Glenn S. Broughton, P.E.
Bohannon Huston
7500 Jefferson NE
Albuquerque, NM 87109

**Re: Truman Middle School Phase 1 Improvements Grading and Drainage Plan
Engineer's Stamp date 5-25-10 and PH 1 DMP Stamp date 7-19-10 (M09/D013)**

Re: Truman Middle School, 9400 Benavides Rd SW
Permanent Certificate of Occupancy – Transportation Development
Architect's Stamp dated 06-07-10 (M09-D013)
Certification dated 12-14-11

**Re: Truman Middle School, 9400 Benevidez, Traffic Circulation Layout
Architect's Stamp dated 06-07-10 (M09-D013)**

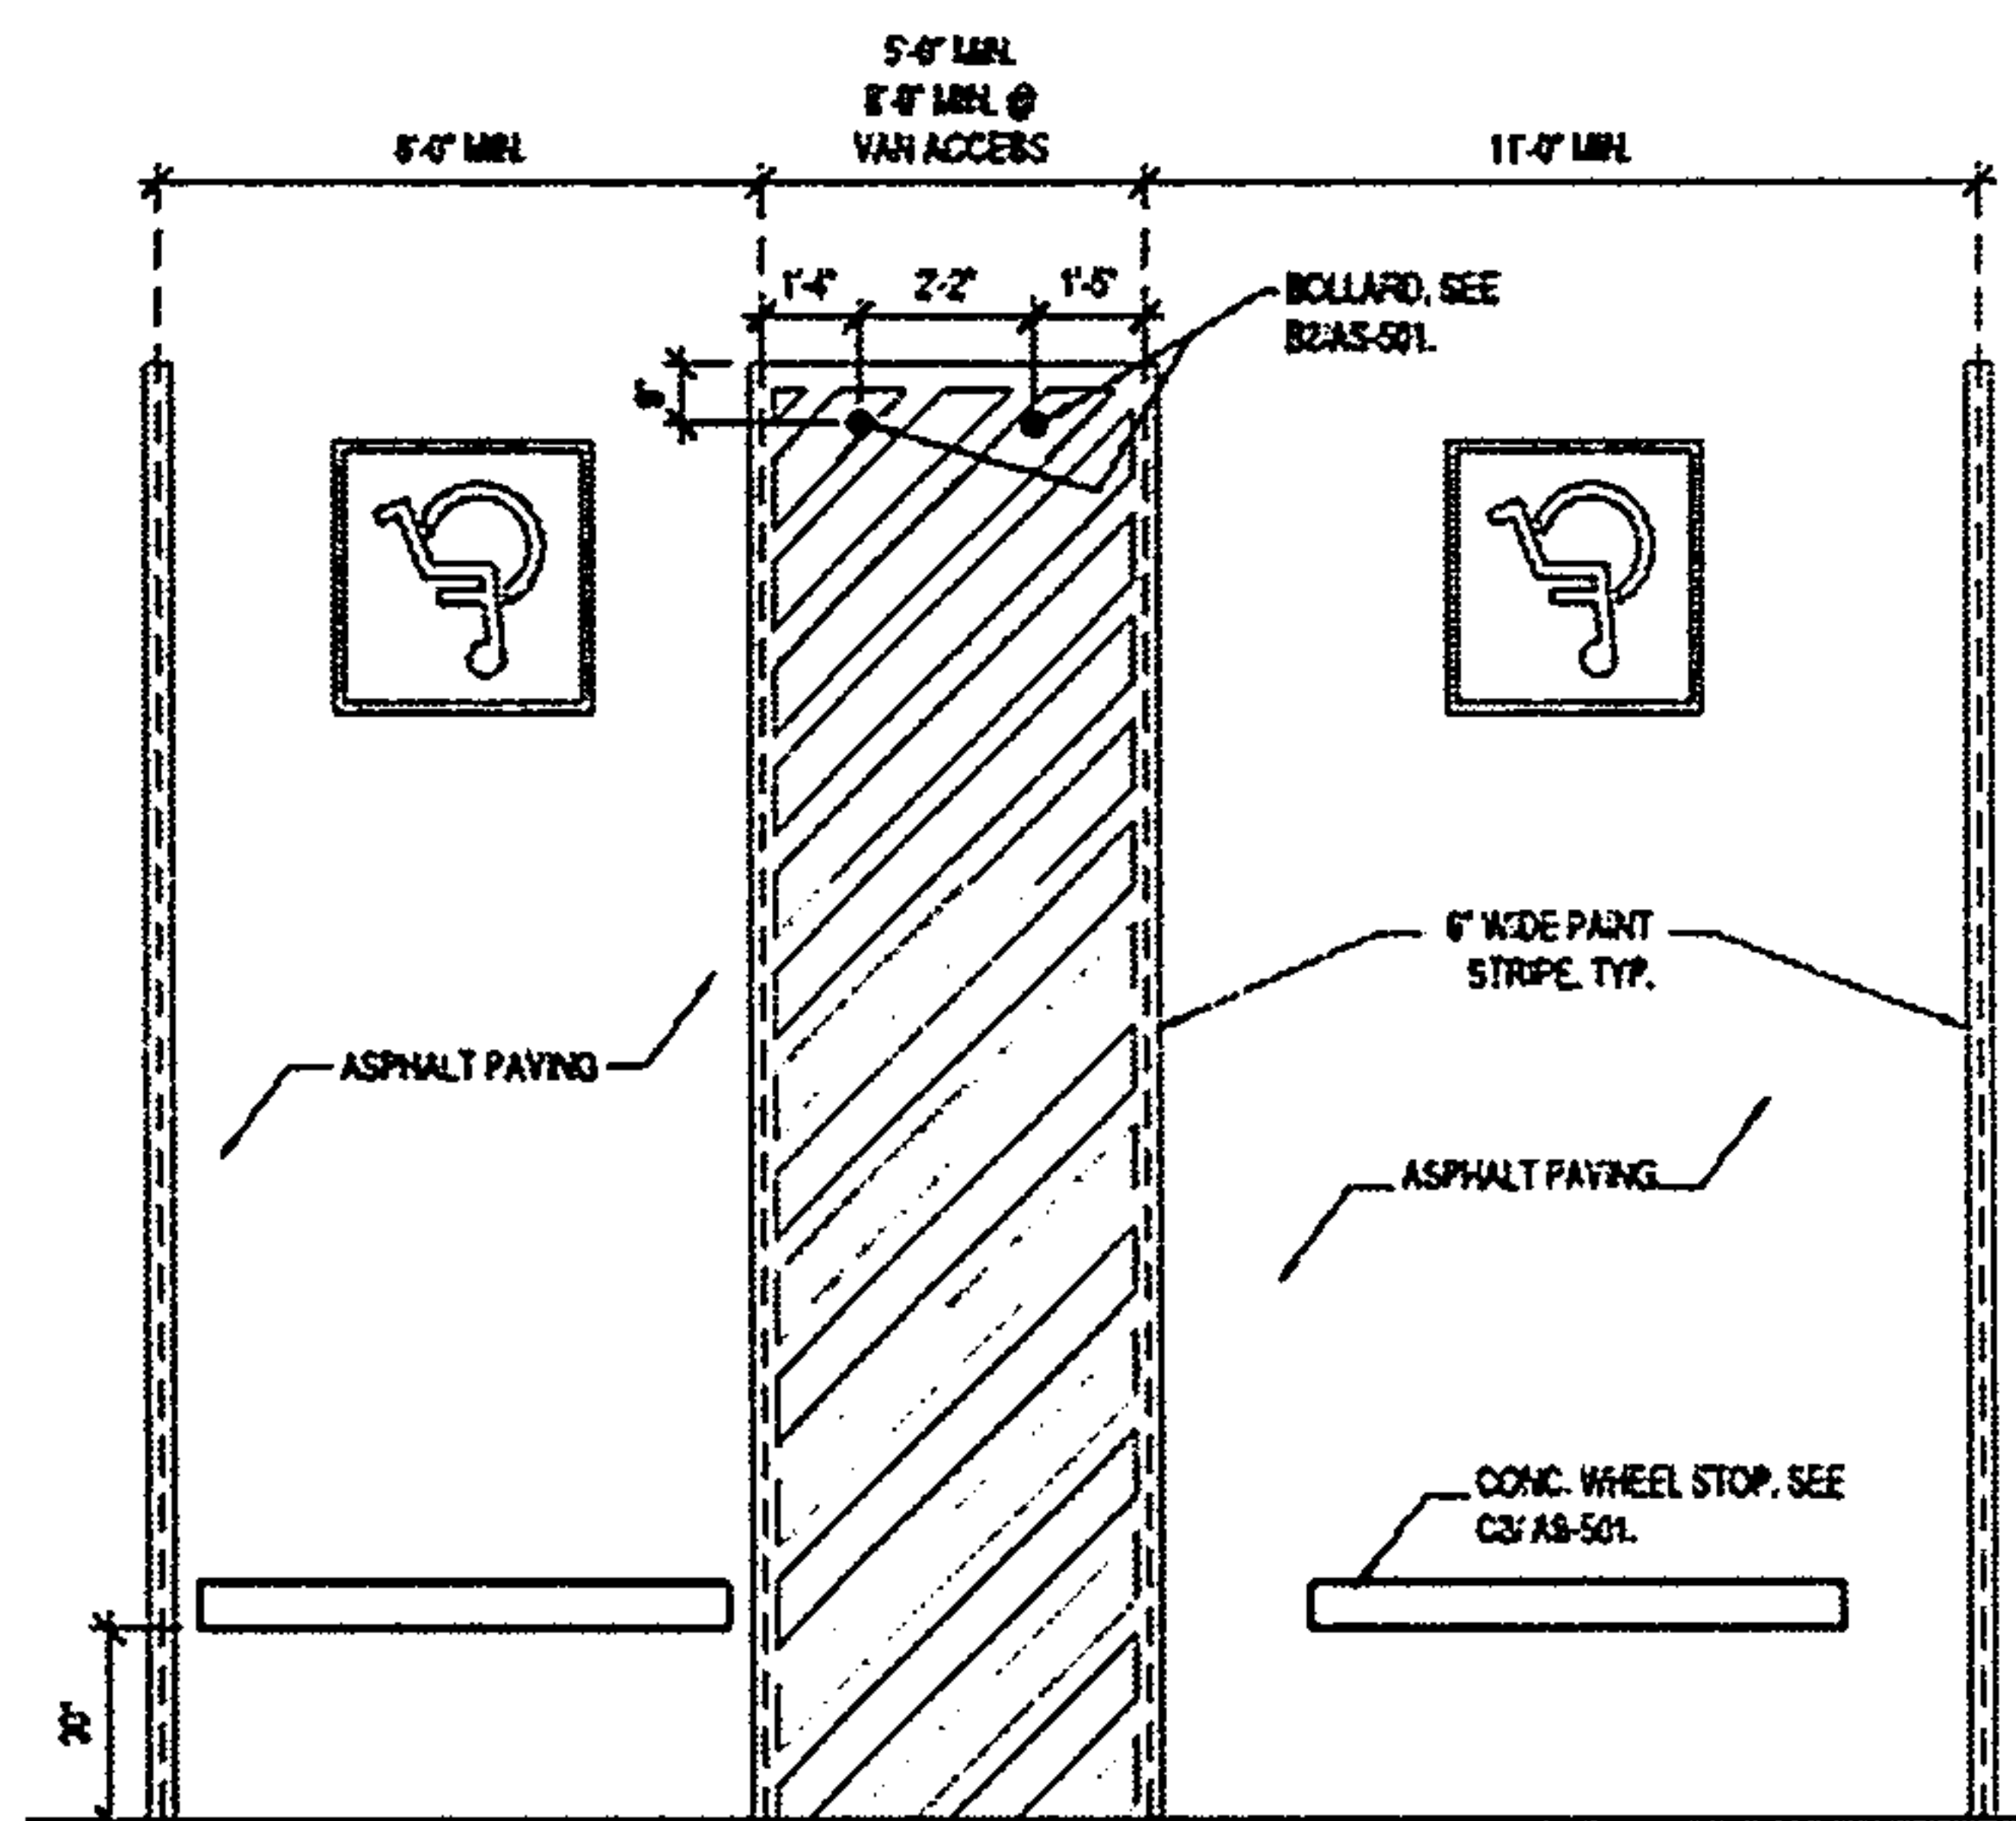
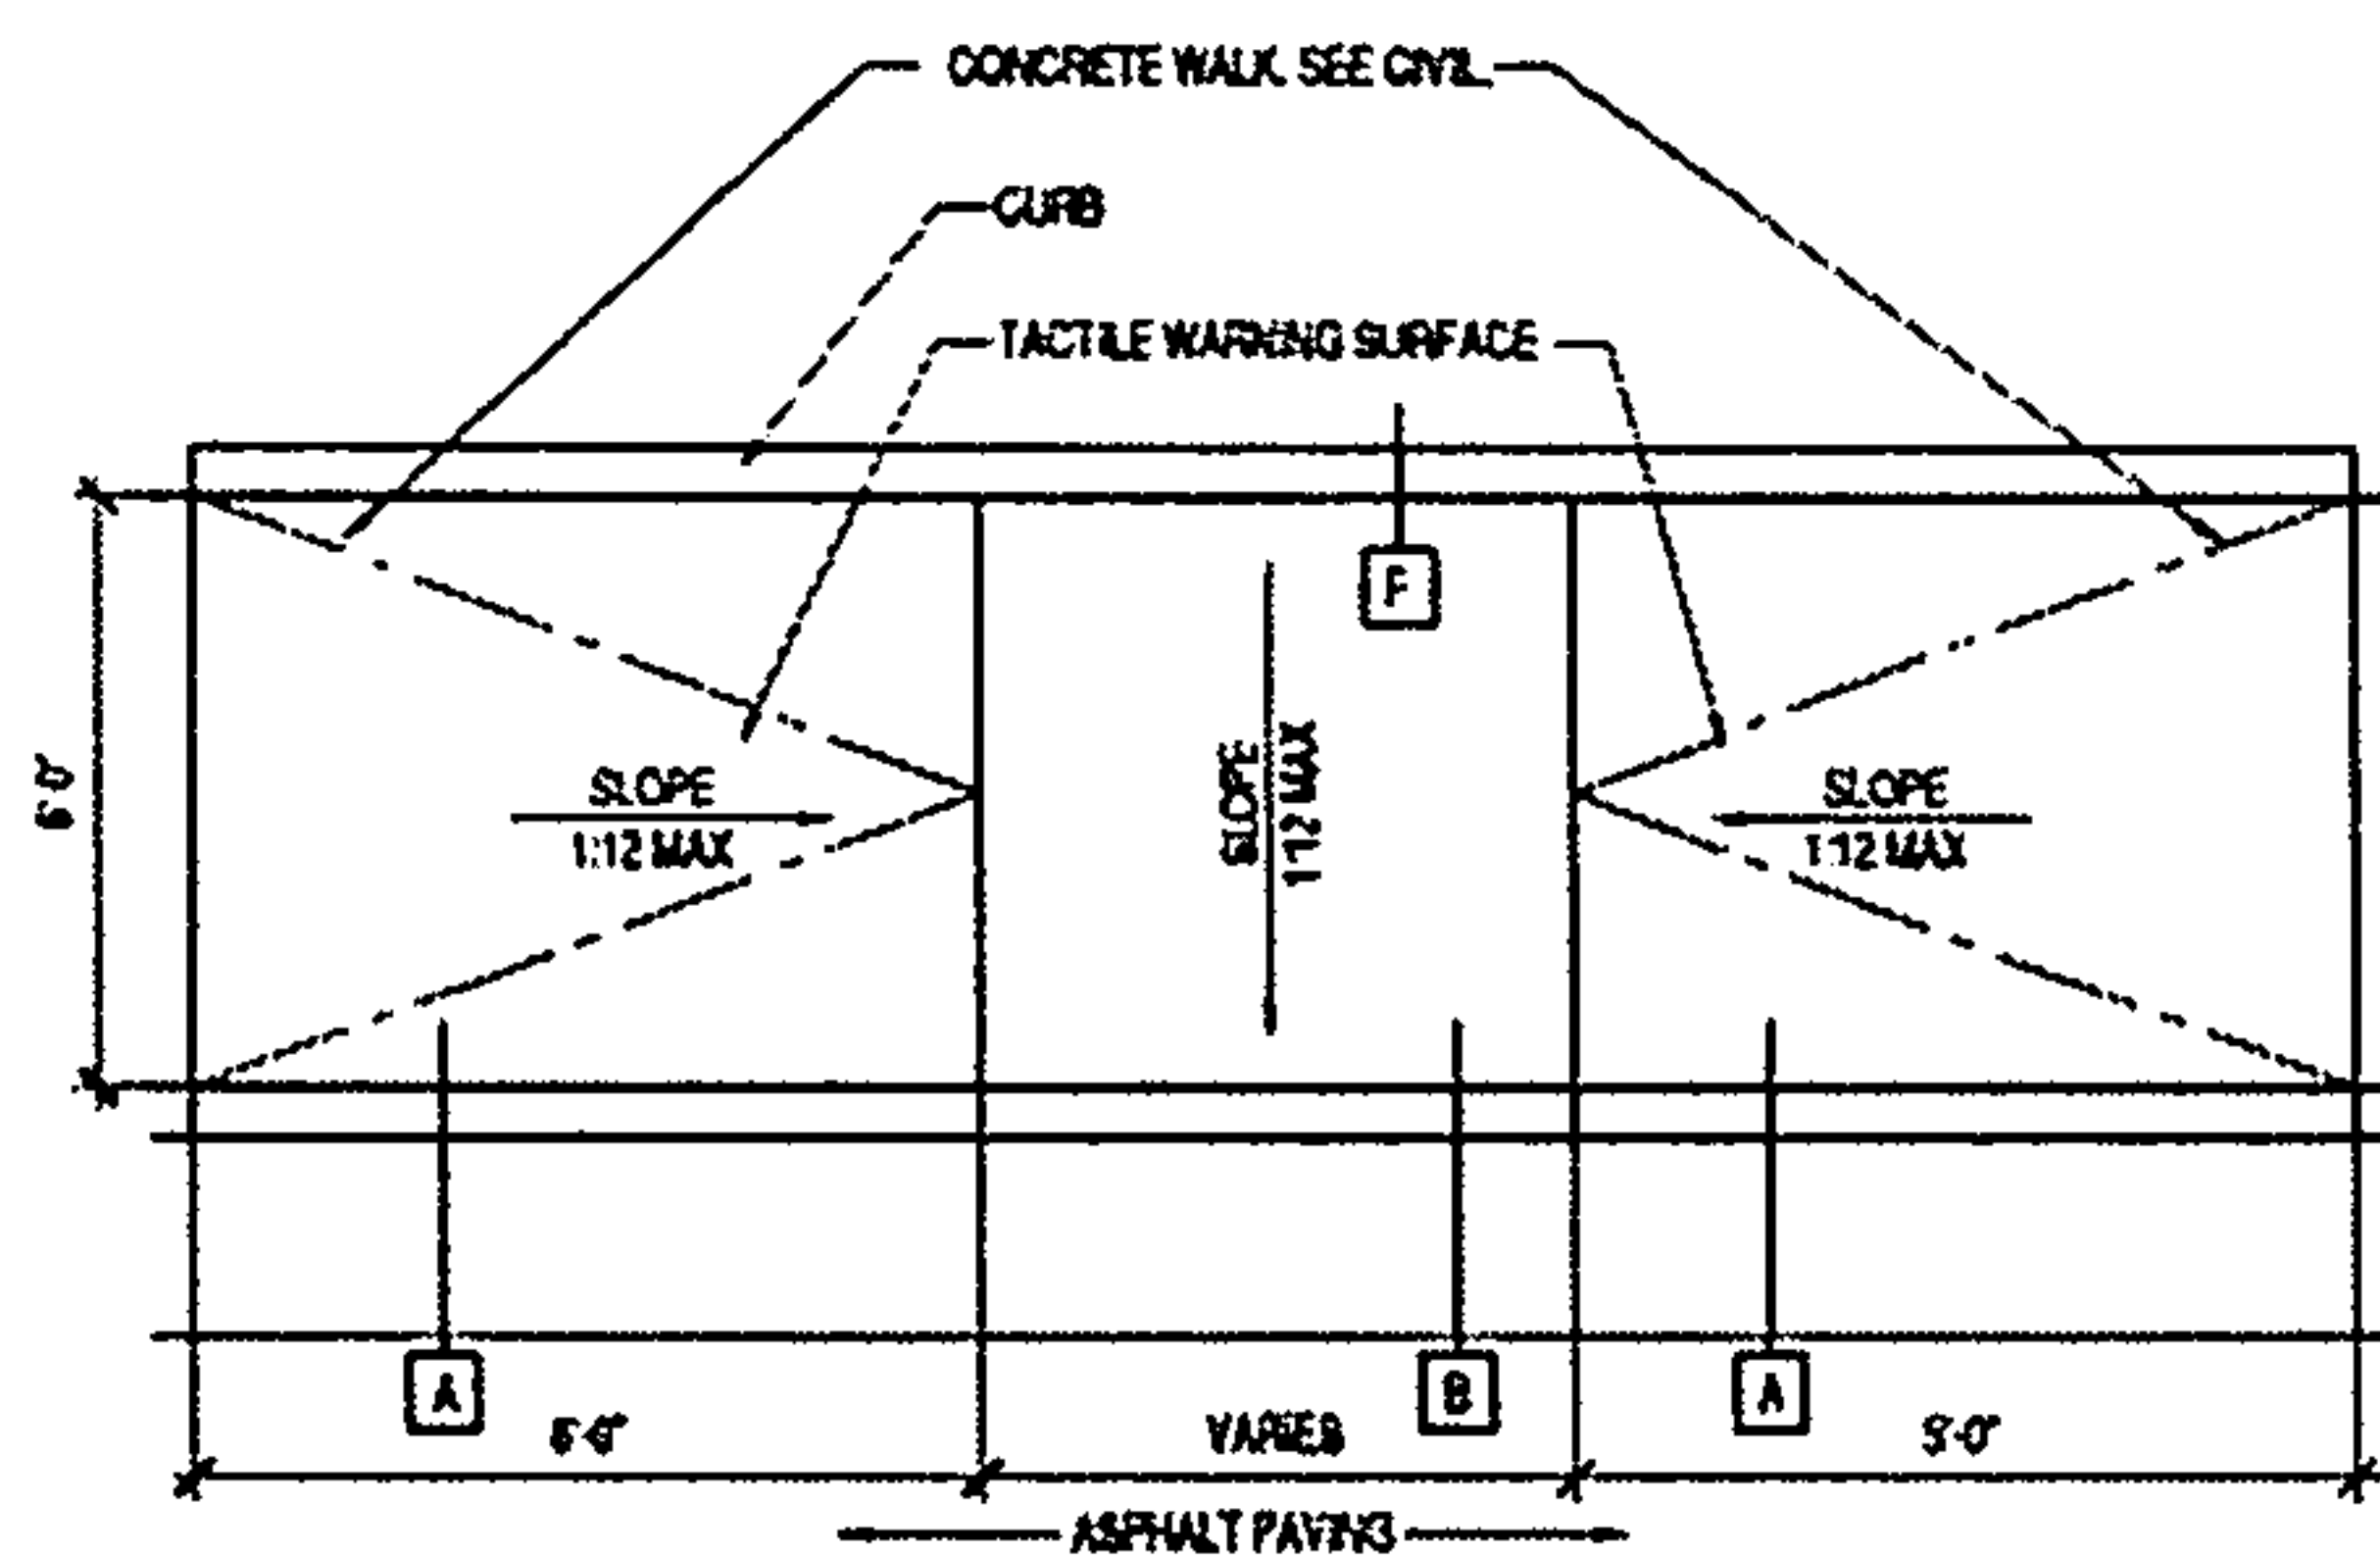
1. Clearly show the 6-foot wide, ADA accessible pedestrian pathway from the roadway to the building.
2. Detail A4 (H.C. Curb Ramp) must be revised. The landing area has a maximum slope of 1:50, not 1:12.
3. Clarify which handicapped parking is van accessible.
4. Bollards are shown within the access aisle of the handicapped parking spaces (Detail A5). These bollards block the clear pathway for the handicapped parking stalls; please remove.
5. Does the new addition have sidewalk along its frontage? If so, why is a separate ADA path shown, and why doesn't this path reach the building?
6. A 6-foot wide, ADA accessible pedestrian pathway must be provided from the access aisle of the handicapped parking spaces to the building. This pathway may not cross behind parking spaces.
